Re: Supplemental Comments on City of Tukwila Shoreline Master Program (SMP)
Update

We represent the James Campbell Co. LLC, which owns property in the City of Tukwila including four parcels along the Green River. This letter addresses an important issue that has been discussed during the City Council work sessions regarding the SMP: the circumstances under which the proposed 125-foot buffer in areas with levees could be reduced following reconstruction of a levee. We are proposing what we believe is a mutually beneficial solution on this issue. We trust that copies of this letter will be provided to the members of the City Council.¹

Conceptual Levee Section I-I' with Floodwall	
Green River Levee Site Tukwila, Washington	
GEOENGINEERS	Figure 1

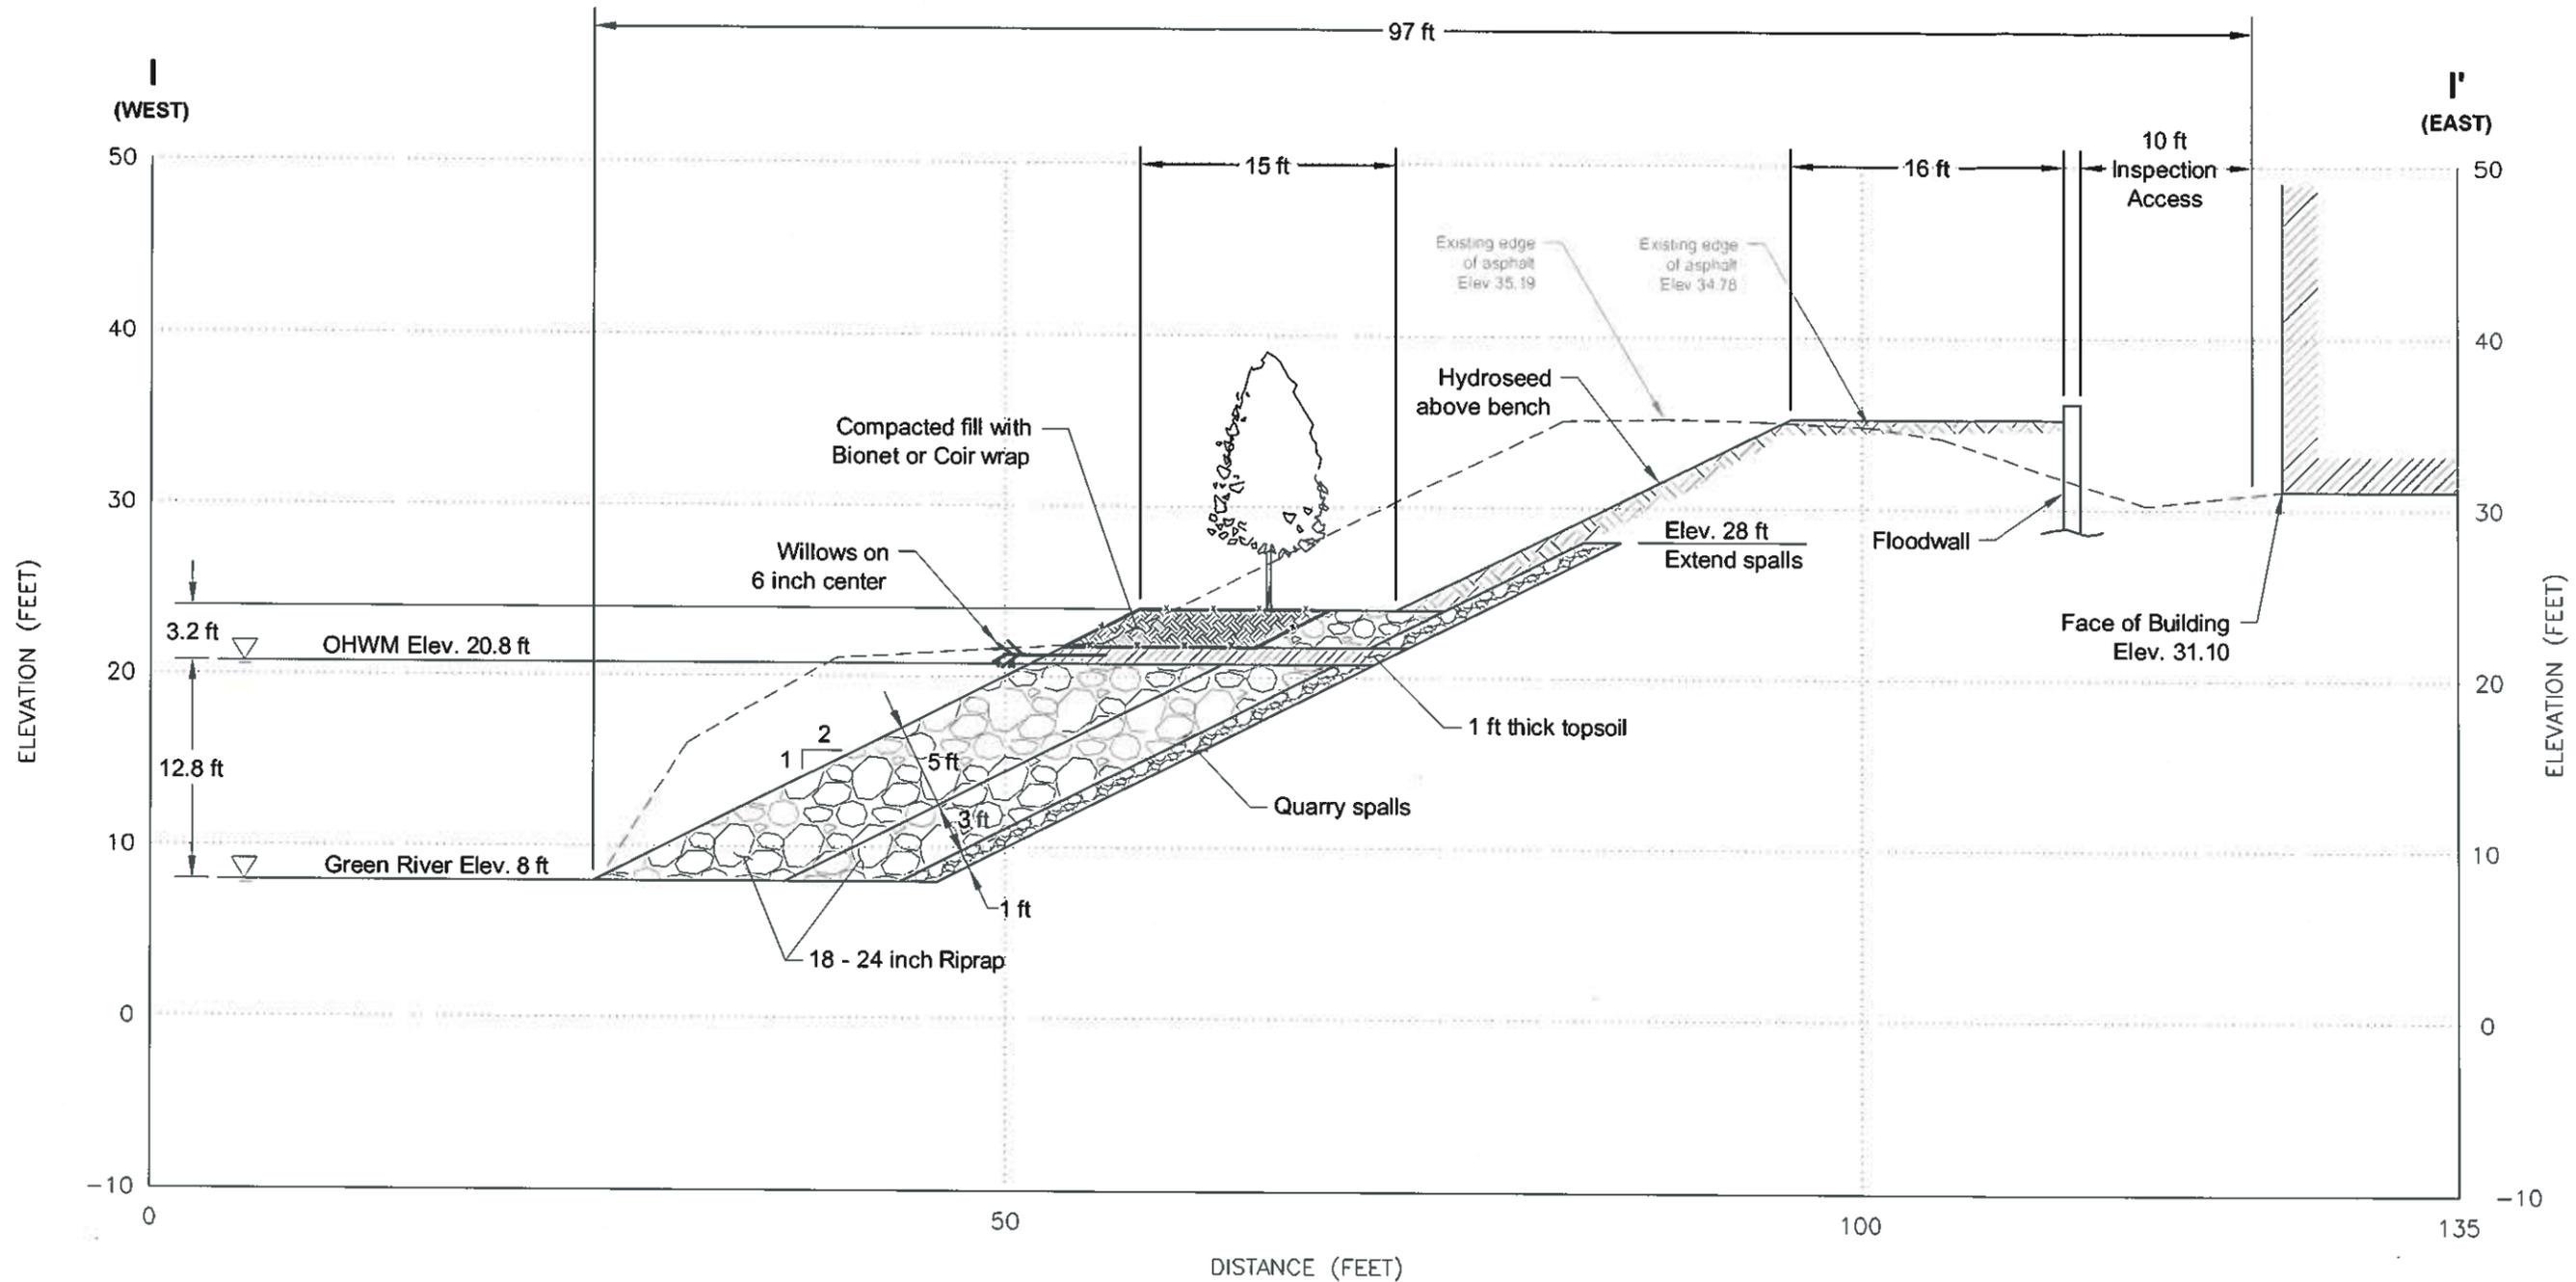
Based on Councilmember Robertson's comments at the working session, the apparent rationale for the Council's refusal to adopt the changes to the SMP proposed by James Campbell Company in its November 10, 2009, comment letter is that, in the event of future sloughing of the levee, additional horizontal distance may be required to achieve the City's minimum levee profile, and thus the buffer line should be set landward of the edge of the existing building.

To address the City's concern consistent with the engineering principles set forth by Geoengineers, we would suggest the following language for the SMP (which modifies the language proposed in our November 10 comment letter):

Where a levee has been reconstructed after 1997 and before adoption of this Master Program and the reconstruction included creation of a midslope bench and planting of native vegetation (but varied in other respects from the Minimum Levee Profile established under this Master Program), and a structure is located landward of such levee and was legally constructed prior to the date of adoption of this Master Program, the portion of such structure that lies within the buffer shall not be subject to the use regulations for the buffer, and may be devoted to any use allowed in the applicable shoreline environment outside the buffer, so long as the structure retains its nonconforming status. Provided that, if repairs are required to such a levee in order to remedy sloughing/erosion and reestablish the preexisting levee toe (not including work to repair damage to a substantial portion of the levee resulting from unusually high water levels or work that goes beyond reestablishing the preexisting levee configuration), the owner of the property adjacent to the levee shall have the option, at its discretion, to make the necessary repairs.
